AMENDMENT OF SOLICITATION/MODIFICATION OF CONTRACT		1. CONTRACT ID CODE	PAGE OF PAGES 1 1	
2. AMENDMENT/MODIFICATION NO. 04	3. EFFECTIVE DATE 08/01/2012	4. REQUISITION/PURCHASE REQ. NO.	5. PROJECT NO. (If applicable)	
6. ISSUED BY NASA/John F. Kennedy Space Center Office of Procurement MAIL CODE OP KENNEDY SPACE CENTER FL 32899	CODE KSC	7. ADMINISTERED BY (If other than Item 6) NASA/Kennedy Space Center Office of Procurement MAIL CODE OP KENNEDY SPACE CENTER FL 32899	CODE KSC	
8. NAME AND ADDRESS OF CONTRACTOR (No., street, county, State and ZIP Code)		(x) 9A. AMENDMENT OF SOLICITATION NO. NNK12438241R	9B. DATED (SEE ITEM 11) 06/29/2012	
CODE		10A. MODIFICATION OF CONTRACT/ORDER NO.		
FACILITY CODE		10B. DATED (SEE ITEM 13)

The purpose of this Amendment 04 is to incorporate the attached Revised Statement of Work.

CAD MAINTAINED. CHANGES SHALL BE INCORPORATED ONLY BY THE DESIGN ACTIVITY		ORIGINAL DATE OF DRAWING (YY/MM/DD) 12/07/20		JOHN F. KENNEDY SPACE CENTER, NASA KENNEDY SPACE CENTER, FLORIDA			
SOFTWARE	DRAFTSMAN J Jingle	CHECKER R Solanky	ACCUMULATOR, NITROGEN TETROXIDE, HYDRAZINE, AND MONOMETHYLHYDRAZINE SERVICE, SPECIFICATION FOR				
FILENAME K0000113580-SPC	ENGINEER F Jan

Figure 1 Bellows Guide and External Support Brackets

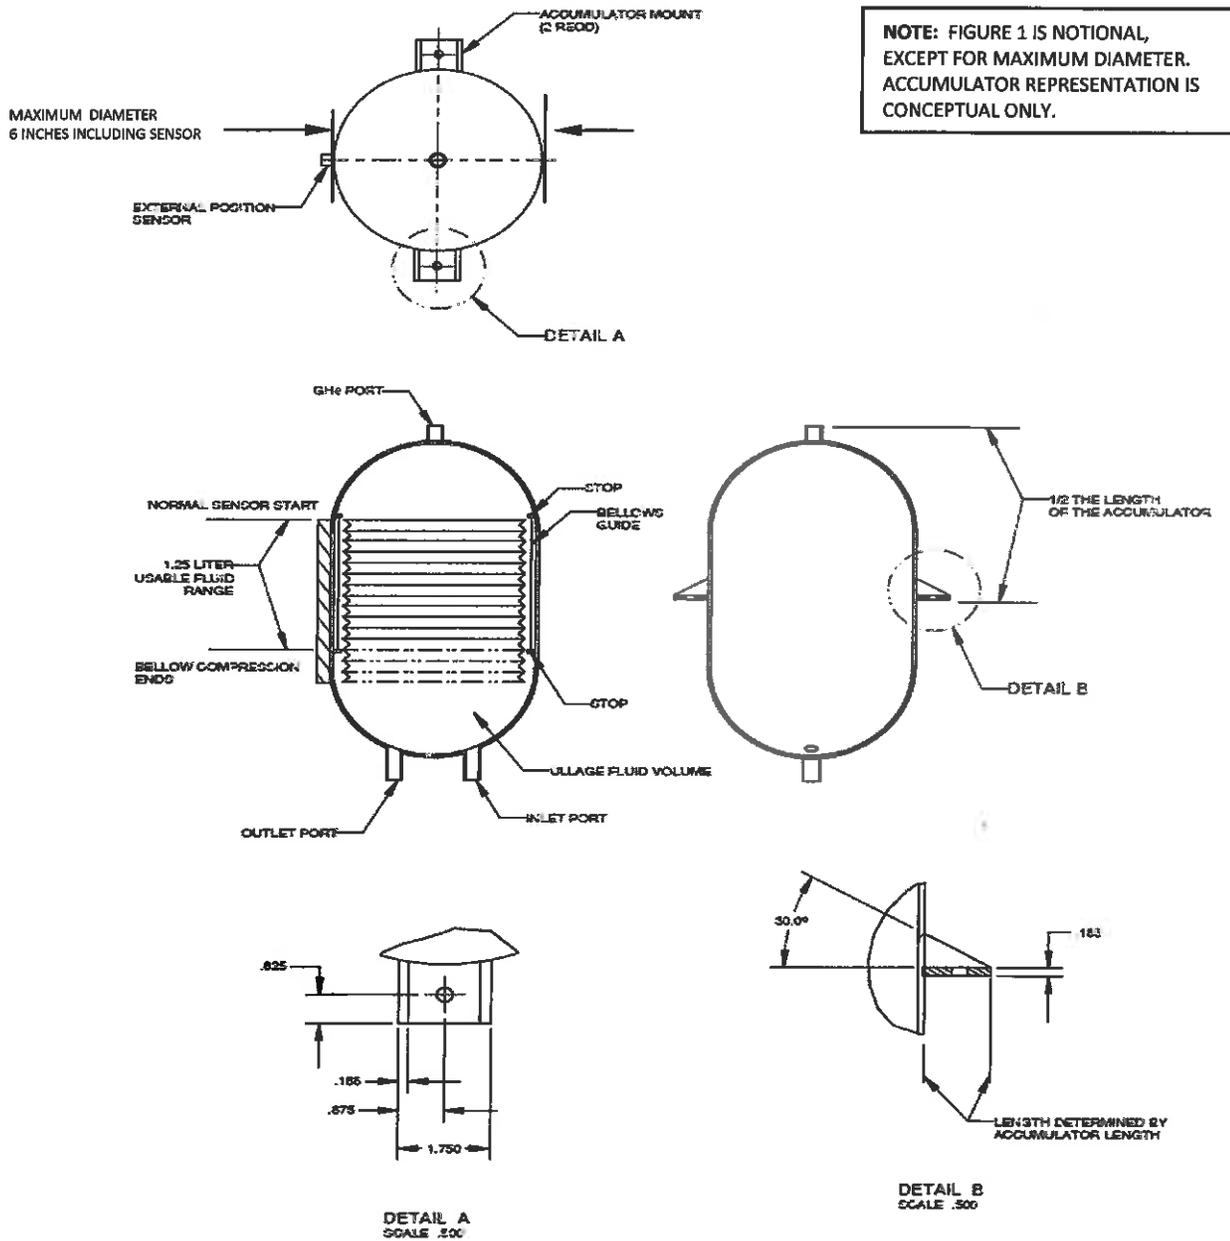
APPLICATION		REVISION HISTORY					
NEXT ASSY	USED ON	PART NO.	ZONE	REV	DESCRIPTION	DATE	APPROVAL
		Para 2.1			Added Spec NASA-STD-6001		
		Para 3.2.1.3		A	Changed 500 to 450 psia (two places) Added reference to operational scenarios and operational scenario table		
		Figure 1		A	Added Note		
		Para 3.2.2.10		A	Revised section		
		Para 3.3.12, Para 3.3.13, Para 4.1.5.1, Para 4.1.5.1.1, Para 4.1.5.1.2, Para 4.1.5.1.3		A	Changed 750 to 675 psia		
		Para 4.1.6.1.1		A	Changed 500 to 450 psia		
		Para 4.1.9.1		A	Changed 1200 to 1125 psia and 500 to 450 psi

- 3.2.2.3 Internal bellows shall be retained by upper and lower stops and guides as shown notionally in Figure 1.
- 3.2.2.4 The accumulator and its subcomponents (bellows, position sensor, stops and guides) shall be evaluated for side loads and vibration to withstand lateral loads of + 2 /- 2 G force (Gravitational load).

3.2.2.12 The accumulator shall have two external support brackets for test hold down as shown notionally on Figure 1.
